ENDL TEXAS

Date: 3 July 2008
 To: SNIA OSD TWG and T10 Technical Committee
 From: Ralph O. Weber
 Subject: OSD-2 CDB Continuations Definition and Usage

Figure 4 — OSD security model transactions

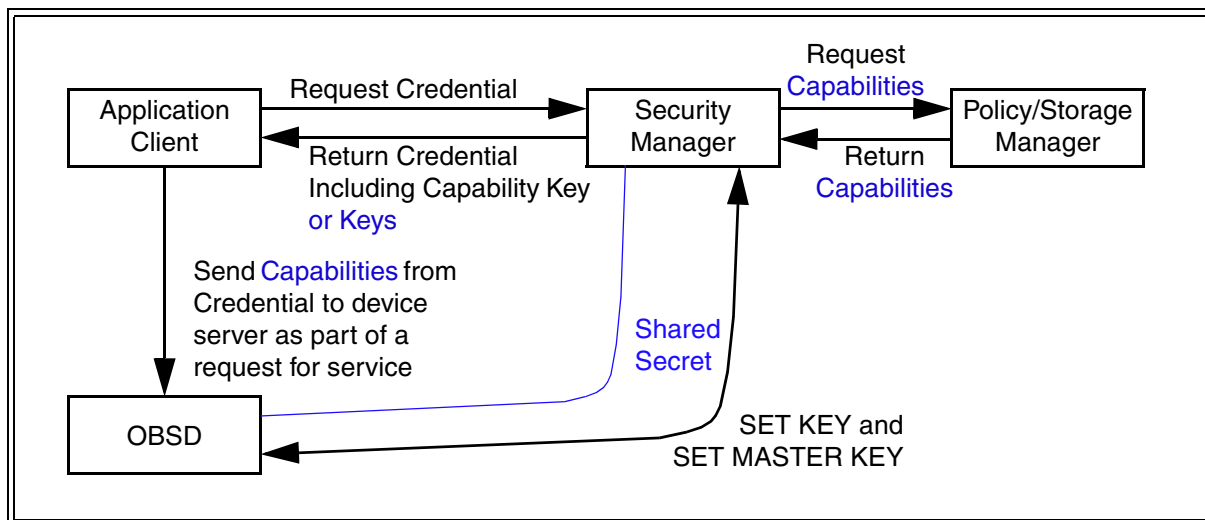
{{With the exception of 'Shared Secret', all the blue text in figure 4 is a replacement for existing text. To keep figure 4 manageable, strikeouts are not show for the old text.}}
